First Amendment to the Draft EIR

# Winchester Ranch Residential Project

File Nos. GP18-014, GPT19-004, PT19-023, PDC18-037, and PD19-019

November 2019

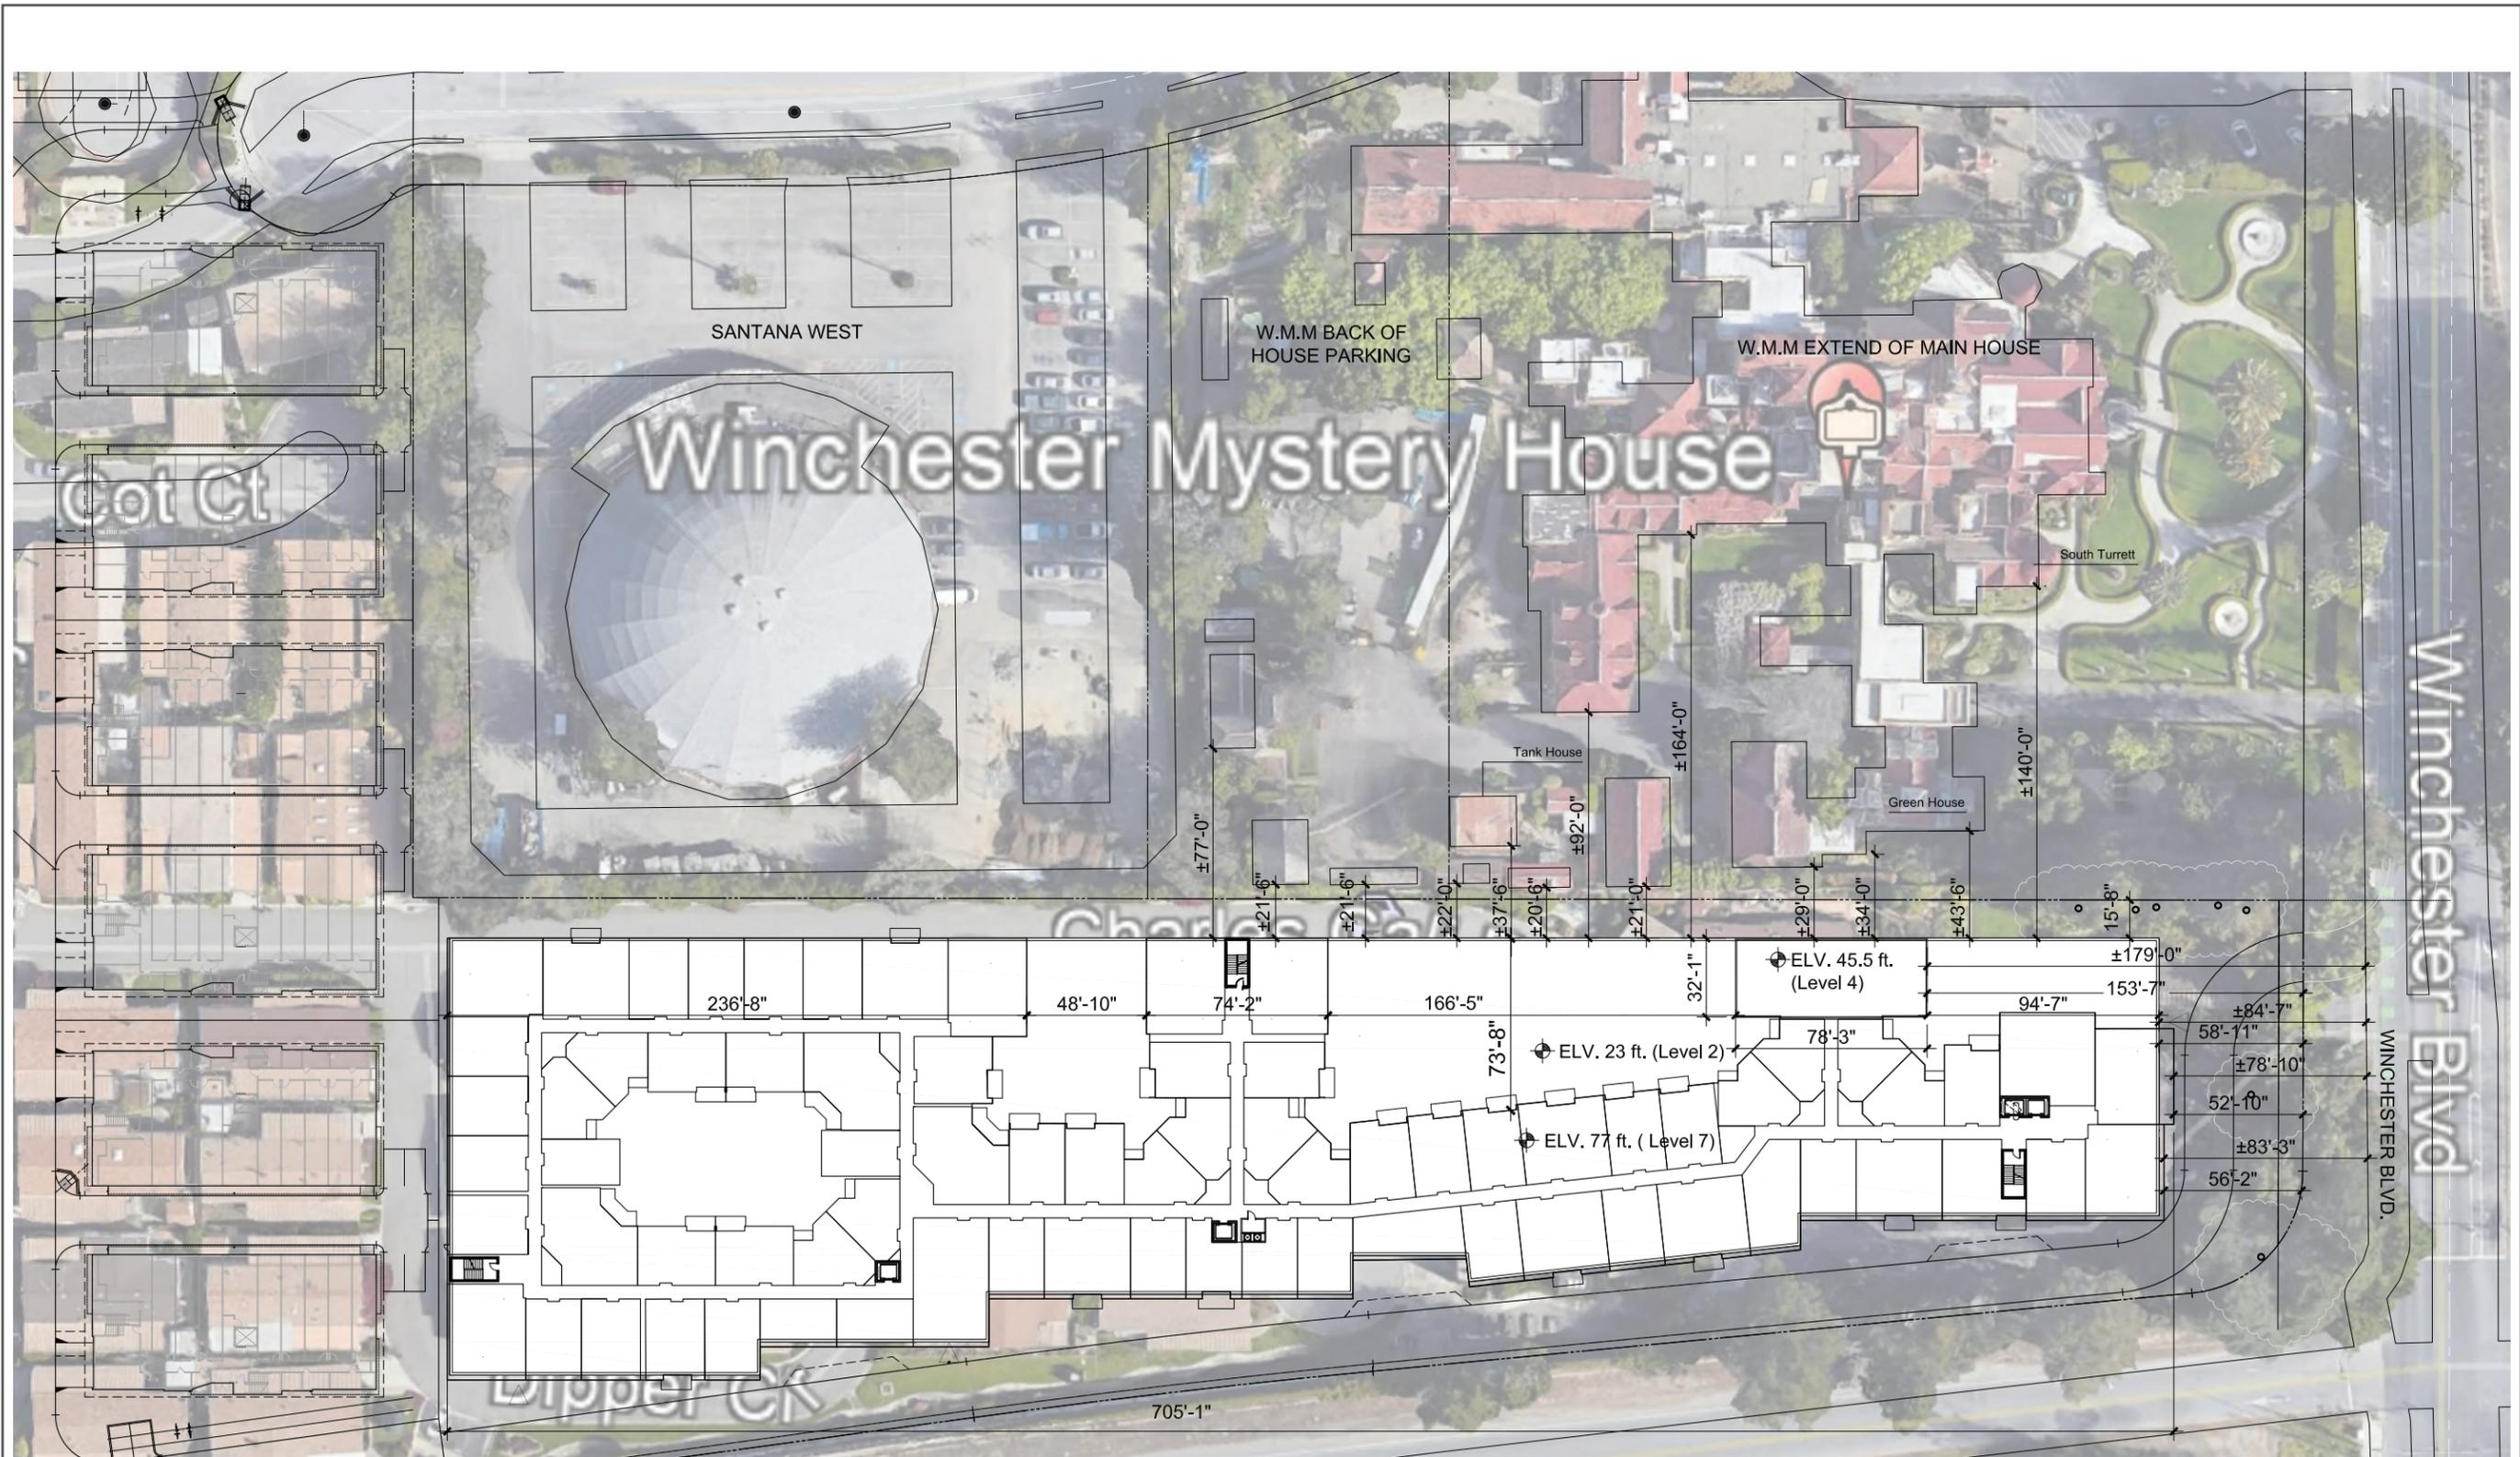
Page 83 Section 3.5.2.1, the impact statement for Impact CUL-1 will be **REVISED** as follows:

The project would not cause a substantial adverse change in the significance of a historical resource pursuant to CEQA Guidelines Section 15064.5. ~~Less than Significant Impact with Mitigation Incorporated~~ **Significant Unavoidable Impact**

MODIFIED REDUCED HEIGHT OF PODIUM BUILDING ALTERNATIVE - CONCEPTUAL SITE PLAN

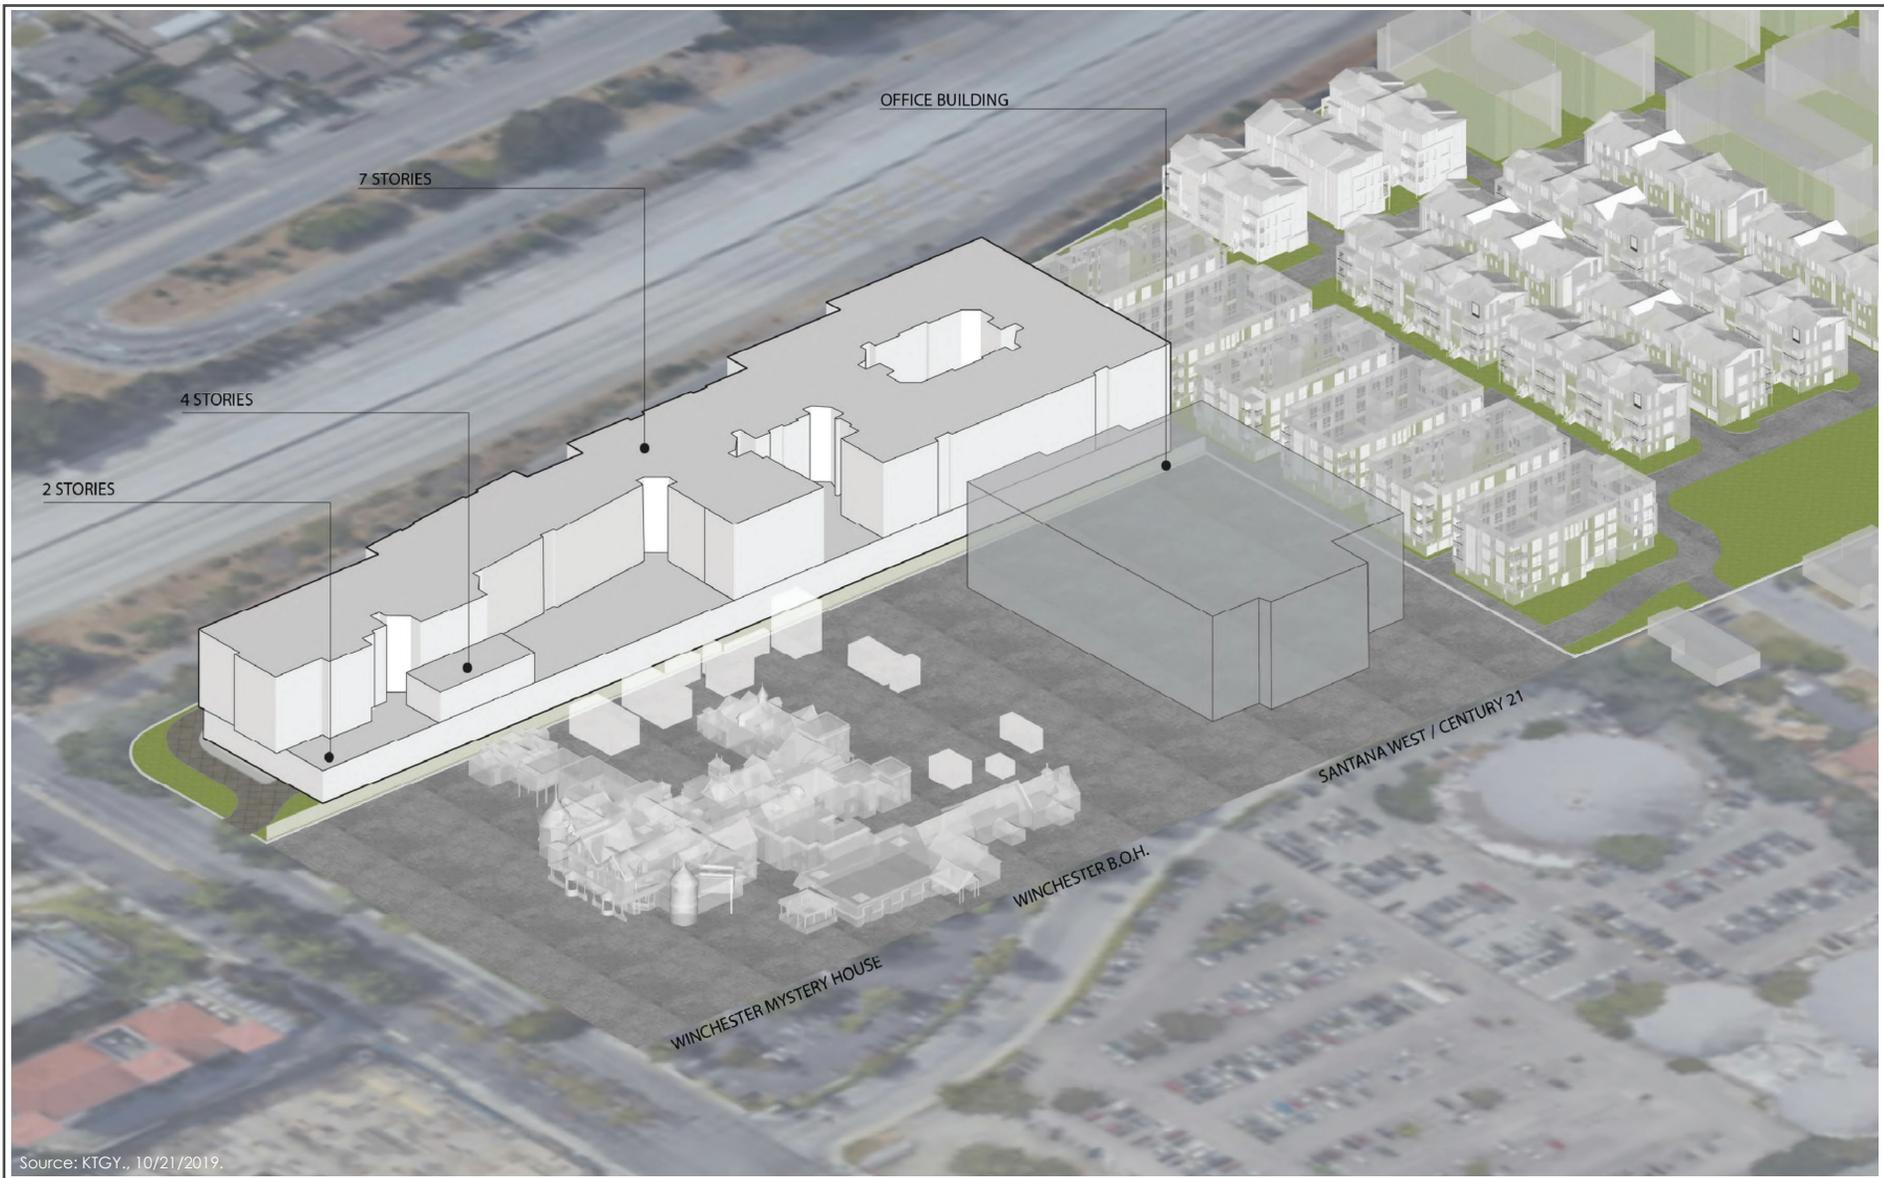
Page 233 Section 7.4.2.4, Preservation Alternatives; a new alternative will be **ADDED** as follows:

The supplemental historic analysis found that the redesign alternative is substantially sensitive to the design of the historic Winchester House and estate. While a large building would still be constructed to the south of the Winchester property, the northern façade has been limited to two stories along much of the property line, presenting more of an appearance of a landscaping wall and increasing the setback from the massing on the upper floors. Based on the supplemental analysis, the design alternative was found to be compatible with San José's policies and regulations, as it can be found to preserve most of the historic integrity of the adjacent historic resources, the Winchester House and Estate. In addition, the mitigation measures identified for the proposed project would be required as part of the design alternative

as a condition of project approval. For all these reasons, the redesign alternative would have a less than significant impact on the integrity of the Winchester House.
